WEST WINDSOR TOWNSHIP

MEMORANDUM

SUBJECT: **ER/UDC West Windsor, LLC – Planning Board Submission #2**
Preliminary and Final Major Subdivision Phases 1 & 2
Preliminary and Final Major Site Plan Phase 1
Preliminary Major Site Plan Phase 2
Block 47, Lots 2, 3, 4, 5 & 6
Princeton-Hightstown Road (CR 571), Southfield Road & McGetrick Lane
PB 22-02

SUBJECT: East Ridge Development - QuickChek and Fast-Food Use
Planning Board Memo #2
Preliminary Site Plan and Rezoning PB 22-02
Princeton-Hightstown Road (CR 571) and Southfield Road
Block 47; Lots 2-6
West Windsor Township, Mercer County, New Jersey

Figure 1: Recommended Layout of McGetrick Lane

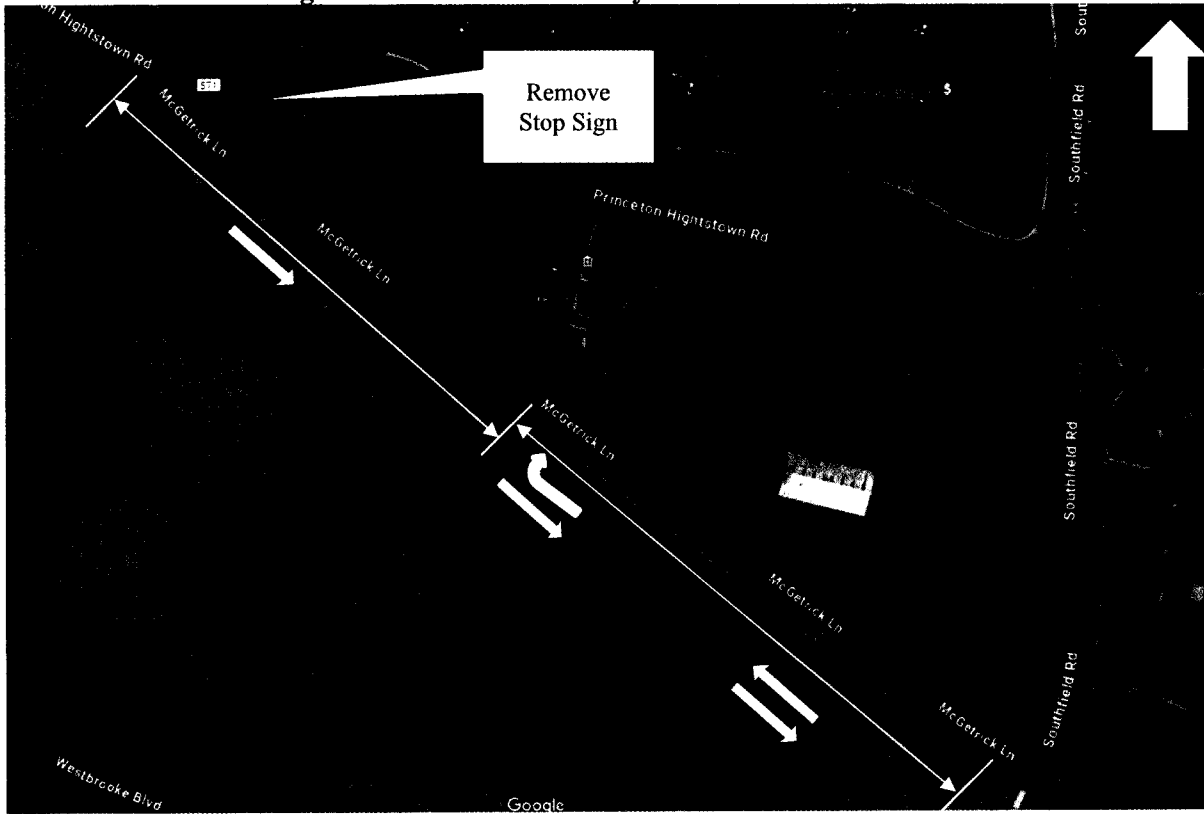
- This memo recommends that the Planning Board and/or the Township Council to revise/amend Township Code Section §168-57 to redesignate McGetrick Lane roadway section to be converted to one-lane-one-way eastbound (from existing two-way configuration) between Princeton-Hightstown Road (C.R. 571) and the Tuttle Dental office driveway. East of the Tuttle Dental office driveway, McGetrick Lane will operate as a two-lane-two-way roadway. The roadway directional layout is shown graphically below.
- Additionally, this memo recommends the West Windsor Township to take appropriate measures to remove the existing Stop sign posted at the corner of McGetrick Lane and CR 571 intersection.

During the TRC Review process, it was discovered that per §168-57, McGetrick Lane is designated as one-way in the eastbound direction. This finding was further investigated, and it was determined that this one-way designation applied to the portion of McGetrick Lane between Southfield Road and C.R. 571 that has since become the CVS site on the east side of Southfield Road and therefore no longer exists. This memo also documents that the Applicant is revising the lower/eastern portion of McGetrick to better align with the CVS driveway and maintain two-way traffic to the Tuttle Dental driveway.

The proposed directional configuration along McGetrick Lane and the recommended removal of the Stop sign are shown below in **Figure 1** through **Figure 4**; where **Figure 3** and **Figure 4** represents the Site Plans received above from both Bohler Engineering NJ, LLC and Atlantic Traffic and Design Engineering, LLC.
